Re: Application for Site Plan Review
Assessor's Map 144, Lot 23
361 Islington Street
Altus Project No. 5356

On behalf of the Owner, Luckly Thirteen Property, LLC, and the Applicant, It's Good to be Kneaded, LLC and Sean Creely, Altus Engineering respectfully submits revised plans and documents for Site Plan Review. Good to be Kneaded proposes to renovate and expand the former gas service station. The existing building and canopy façade will be retained. Parking and site access will be improved by eliminating egress onto Islington Street. Landscape and drainage improvements will reduce runoff and improve stormwater quality and enhance the aesthetics of the property.

On February 7, 2023, the Portsmouth Technical Advisory Committee voted to recommend approval with 10 conditions.

Landscape Plan

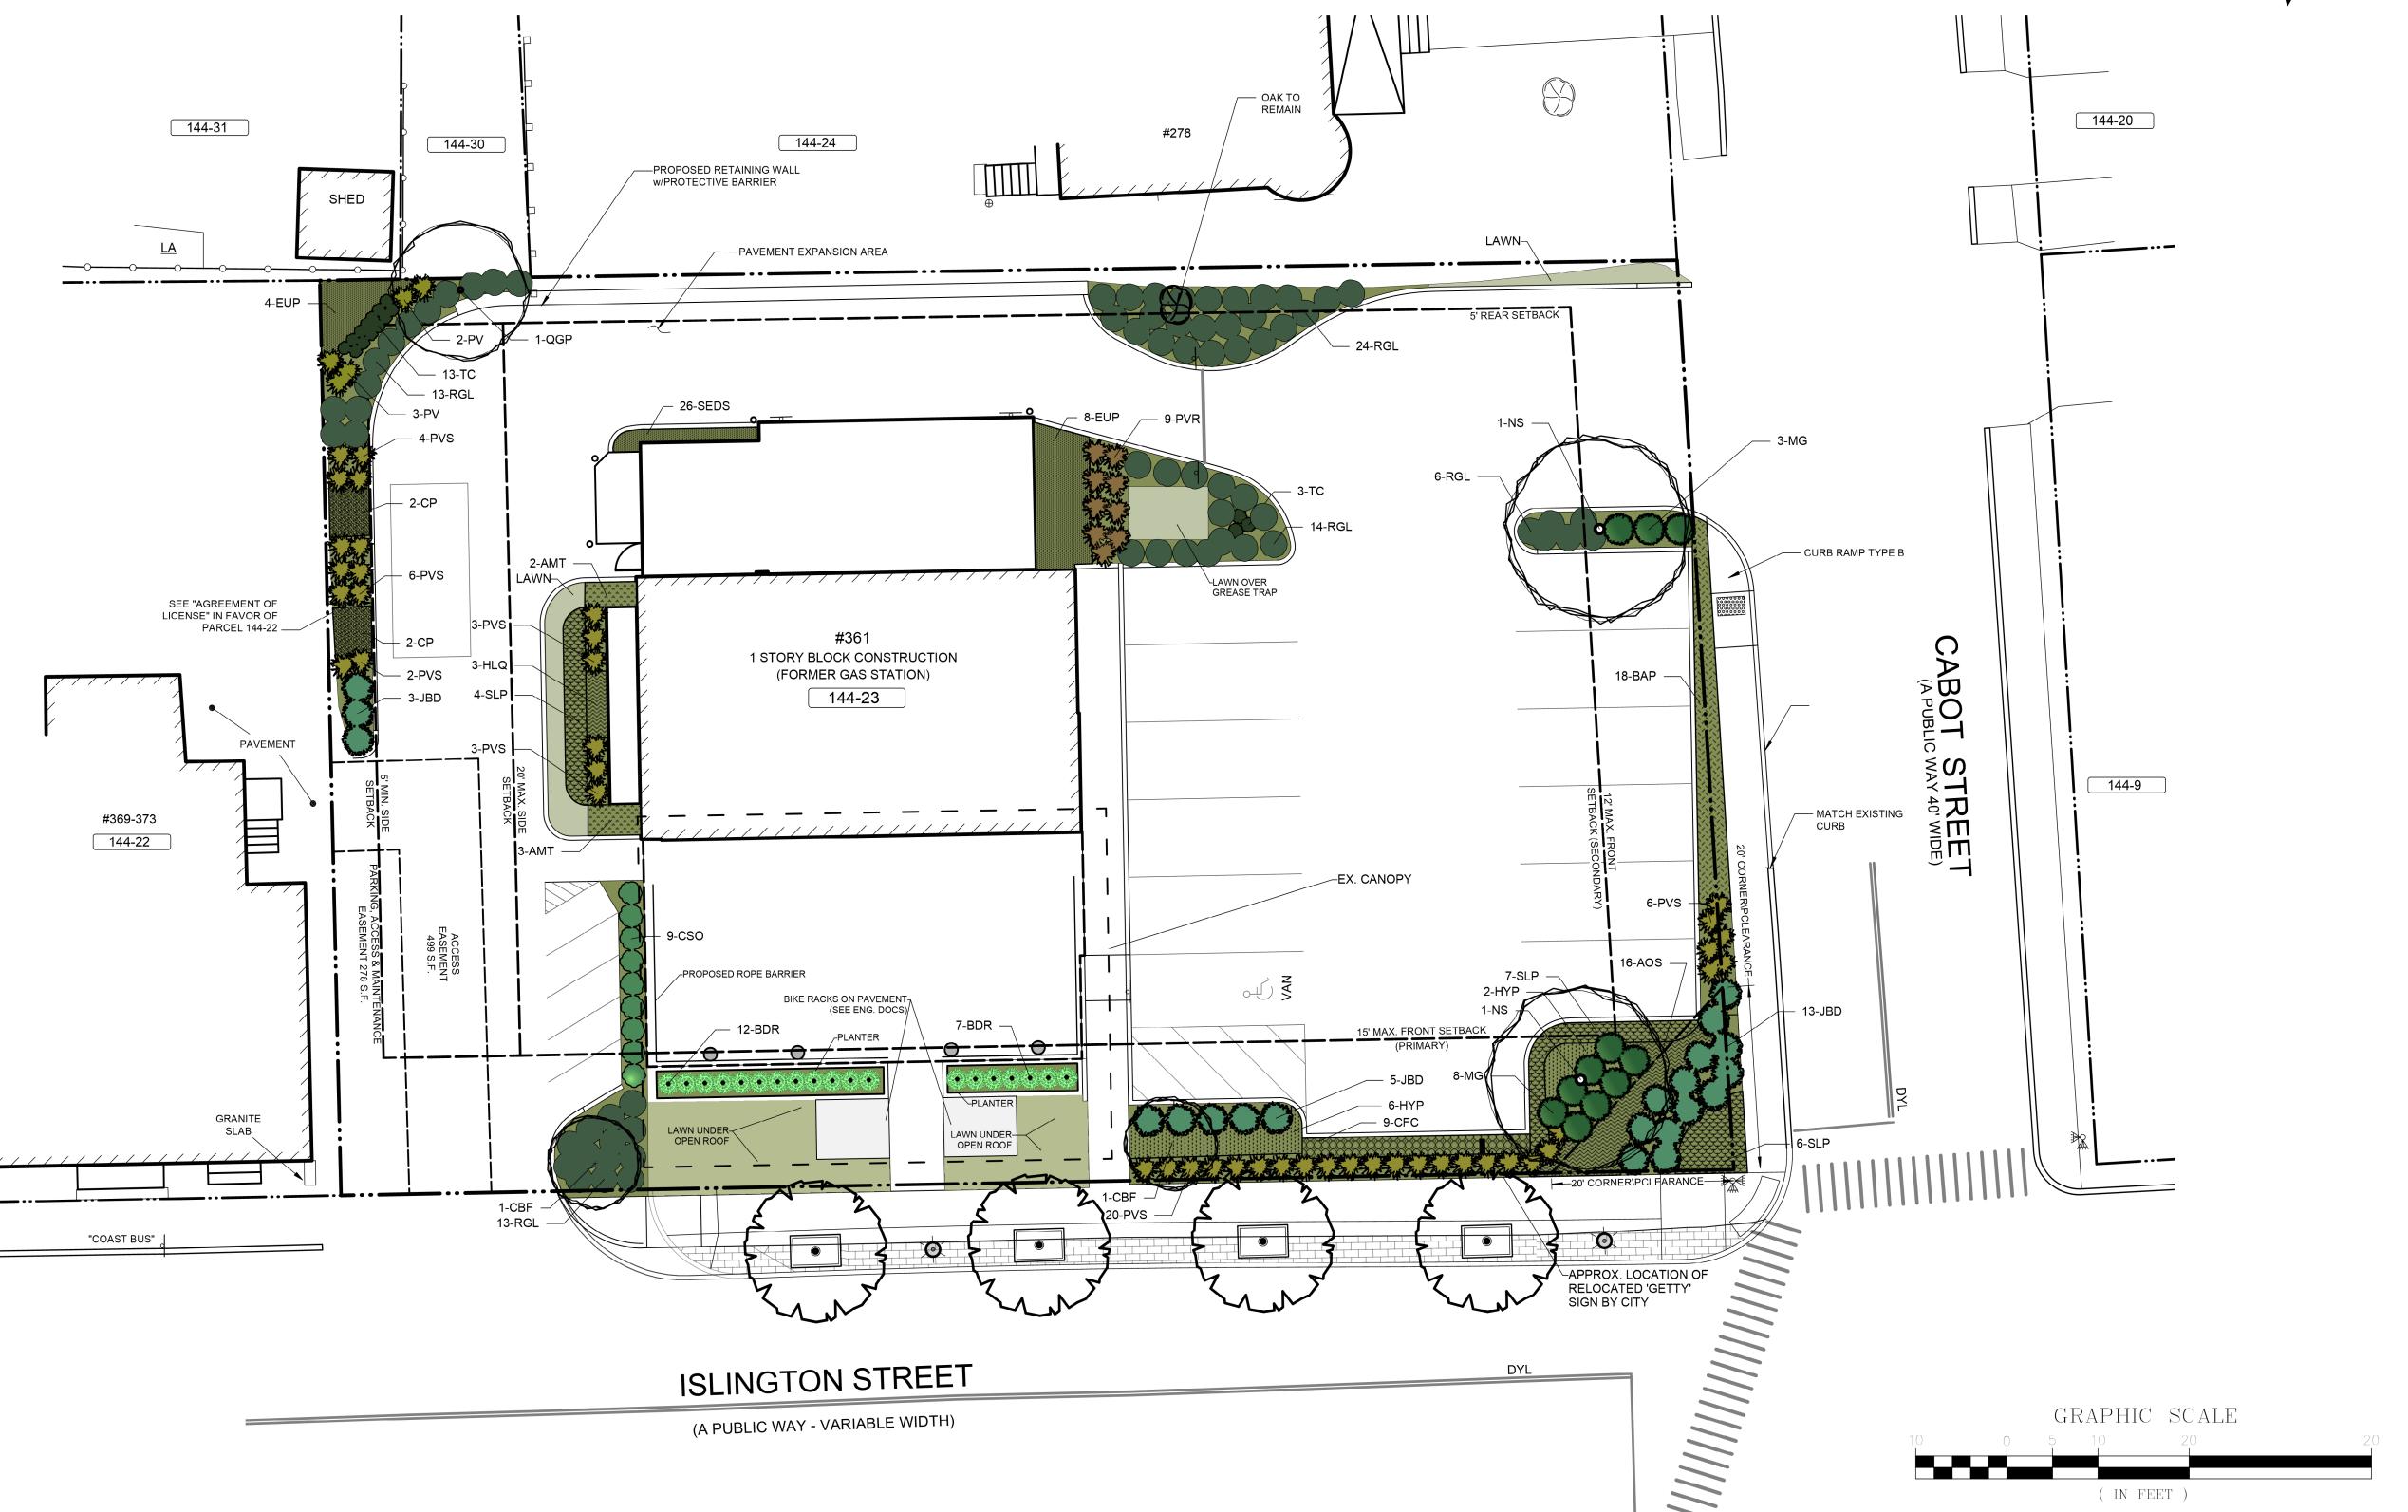
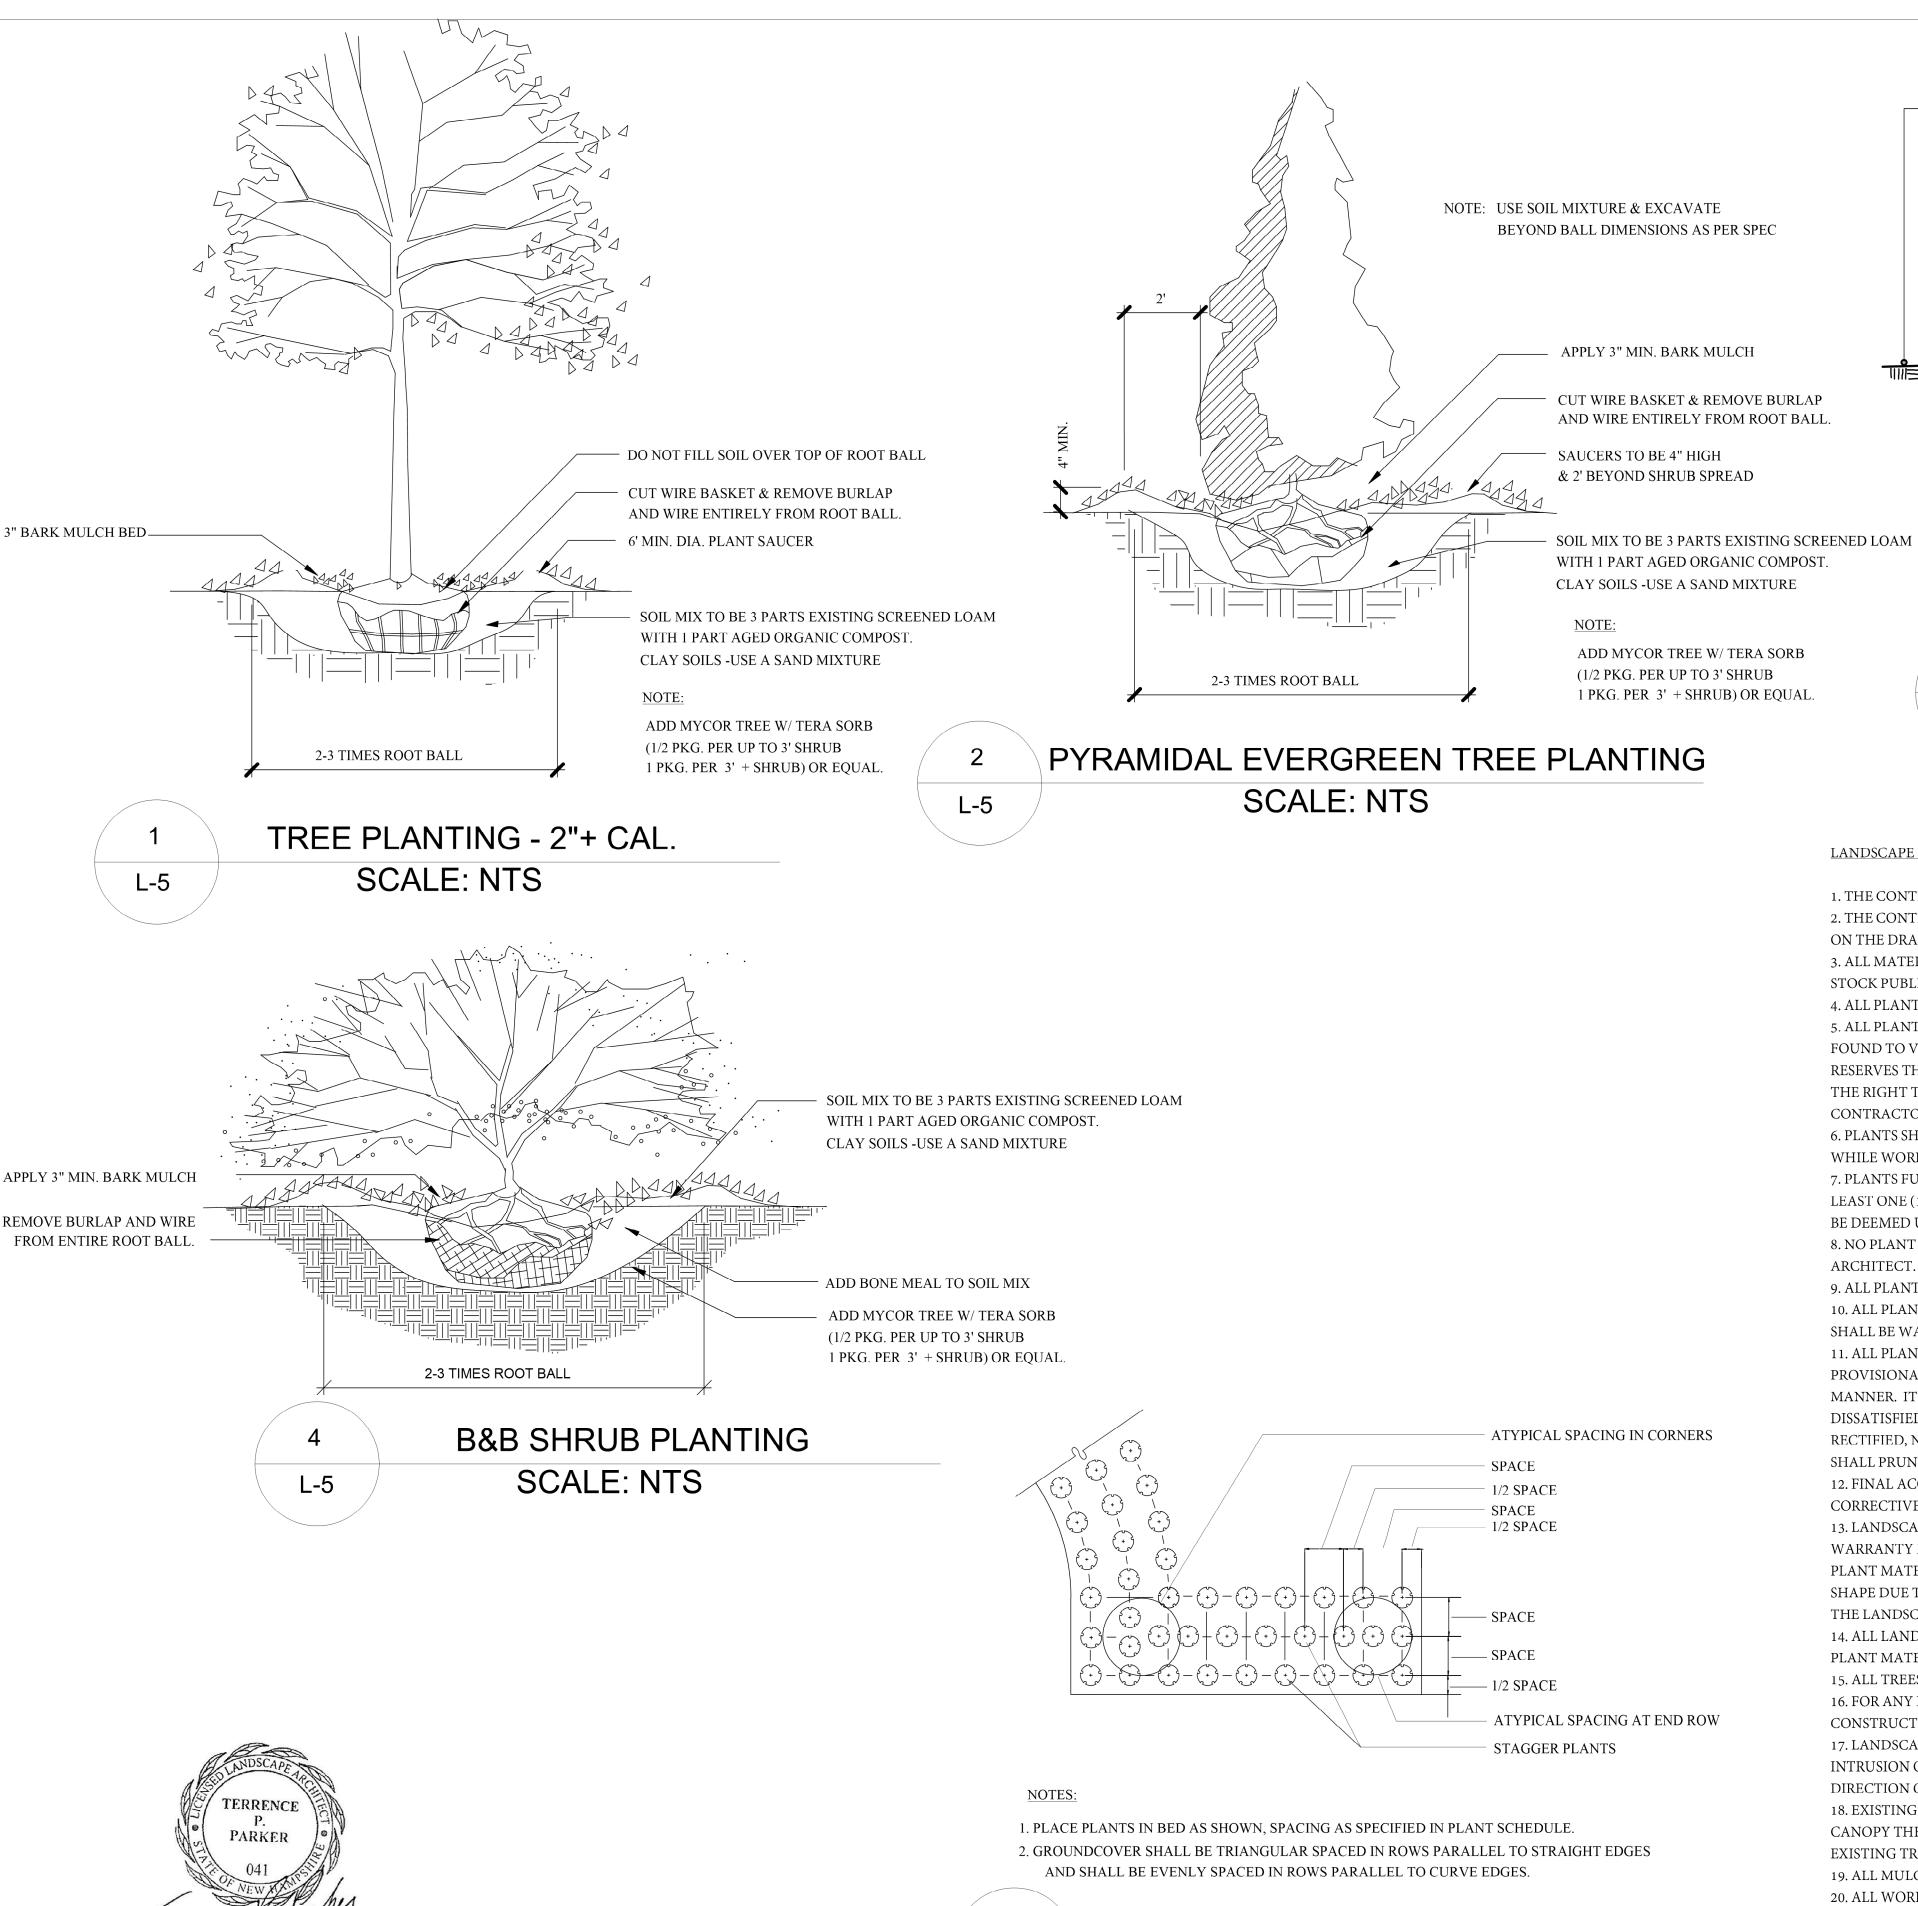
- 6. The landscape plans have been revised to note that the cage and burlap will be removed from the tree plantings.
- 7. Note 16 on the Site Plan, Sheet C-2 has been modified to confirm that the proposed site lighting will be dark sky compliant.
